April 30, 2015

**RE: Starbucks and Burger King, Tract 338-B, 1000 Rio Grande Blvd. SE
Grading and Drainage Plan
Engineer's Stamp Date 3-30-2015 (File: H13-D021)**

1000 RIO GRANDE BLVD., NW GRADING AND DRAINAGE PLAN			
DRAWING:	DRAWN BY:	DATE:	SHEET #
201309-GD.DWG	SH-B	10-25-2014	2

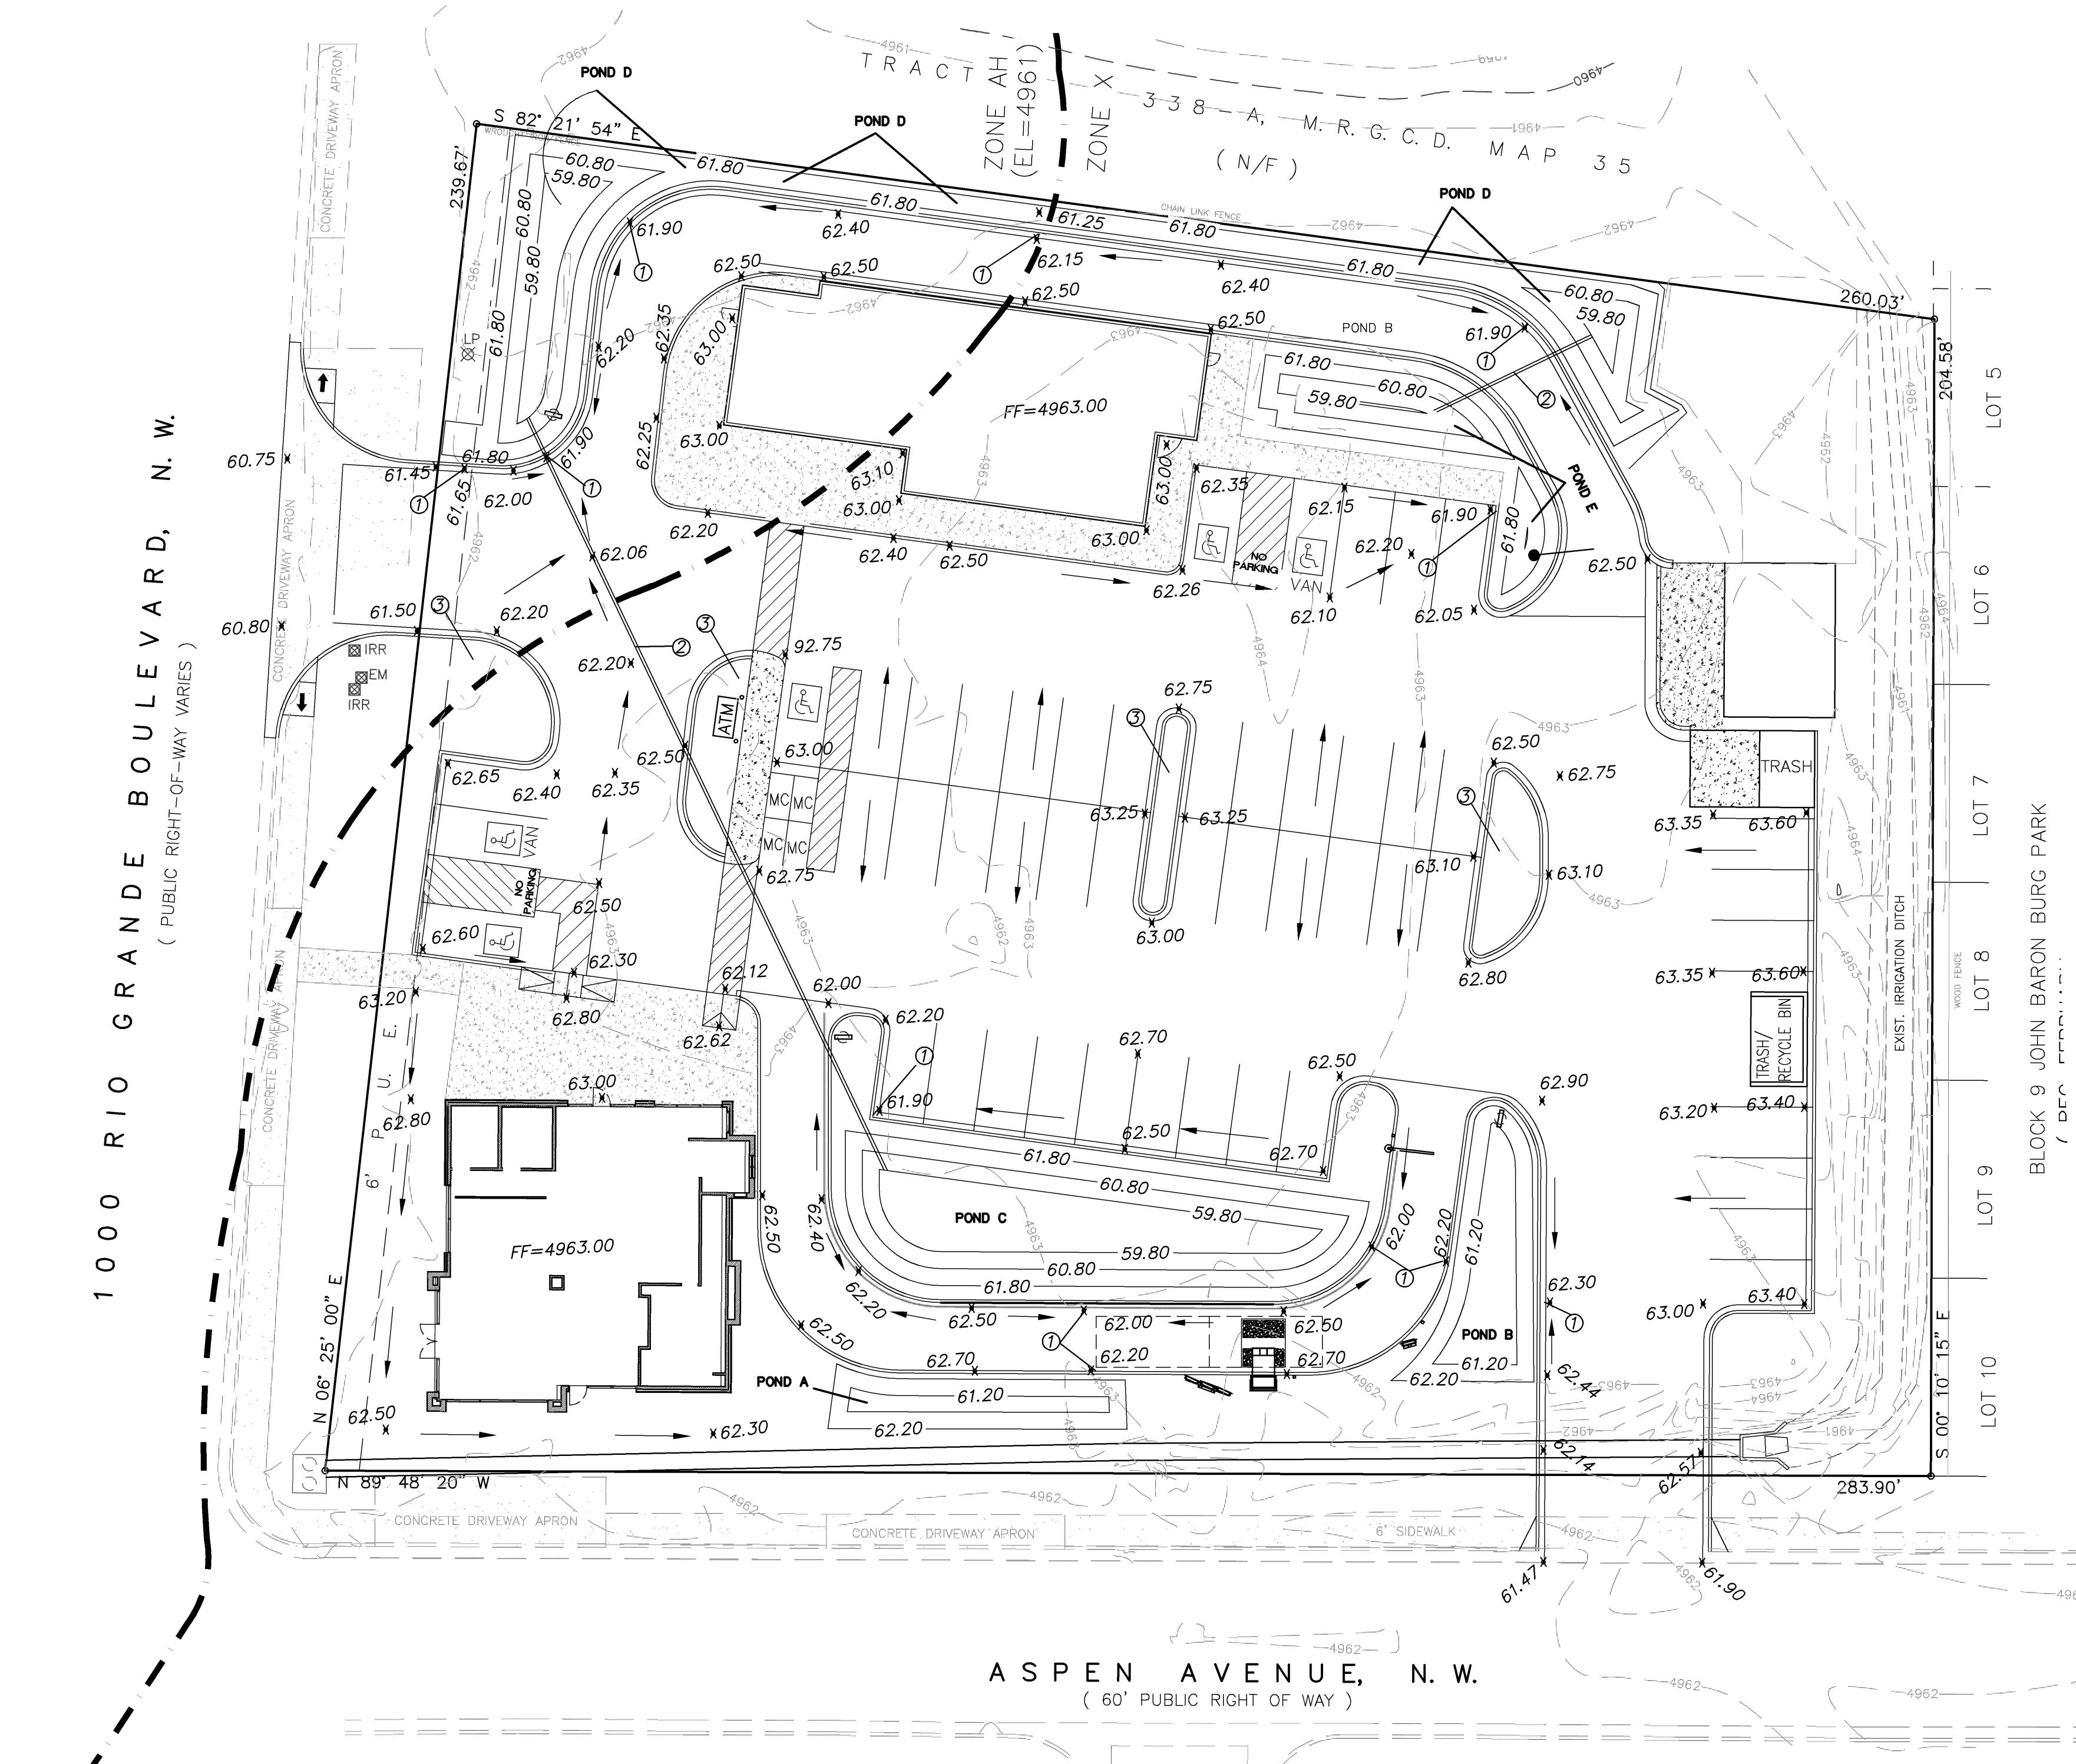
- 1) Provide a survey benchmark and existing spot elevations along the entire site perimeter. These are particularly important at the north and eastern boundaries. Also, provide existing curb elevations on Rio Grande Blvd.

- 2) A sidewalk culvert needs to be provided from Pond D to Rio Grande Blvd. Call out COA Std. Dwg. 2236 for the sidewalk culvert. In the valley, a maximum discharge rate of 2.75 cfs/acre from the site can be allowed, or ½ inches of runoff can be retained. It is preferable to discharge a rate of 2.75 cfs/acre from the site.

- 3) Indicate the floodplain boundary in the legend. Because you are constructing in the floodzone, please request a floodplain permit. An elevation certificate must be provided prior to Certificate of Occupancy. Additionally, for any fill you are bringing into the floodplain area, a compensatory volume of excavation must be provided. Please discuss how you are addressing this in the write-up.

- 4) If the pipe between Ponds D and C is meant to be an equalizer pipe, a larger size of pipe than 6" would be recommended. Explain the pipe's capacity to function as an equalizer pipe. Also, provide invert elevations at all on-site pipes.

- 5) Show the direction that the roofs drain. Indicate which ponds are retaining the first flush pond volume and note it on the plan view along with the first flush volume per pond.

6) Show the existing pipe and pipe size for the irrigation pipe under the new driveway to Aspen Avenue to demonstrate adequate pipe cover. Have a note for the irrigation ditch facilities to remain undisturbed.

7) Provide capacity calculations for the proposed sidewalk culvert and on-site curb cuts. The scale on the plans is shown as 1:10, but it appears to be 1:20. Revise as needed.

8) It is not desirable to have a curb cut close to the north boundary of the site where it is too close to the property adjacent to the north. Is much of the roof draining to the north for the northern building? Could this flow be directed to the western side of the site where it is closer to the outfall and have a larger curb cut provided? In the write-up, discuss the impact of the on-site improvements to the property to the north or lack thereof.

10) Provide more spot elevations for the swale along the north side of the site and within the drive-thru between Pond D and E. The 92.75 elevation shown within the parking lot at the corner of one of the handicapped parking spaces is in error.

11) Provide the total for the pond volumes under the pond volume calculations at the bottom of the sheet. The summation of the pond volumes provided does not equal the pond volume calculations in the write-up. Take the language about draining to inlets out of the write-up if the site is not draining to any inlets. In the narrative for the "Existing Drainage Conditions", include a statement about historical flow patterns.
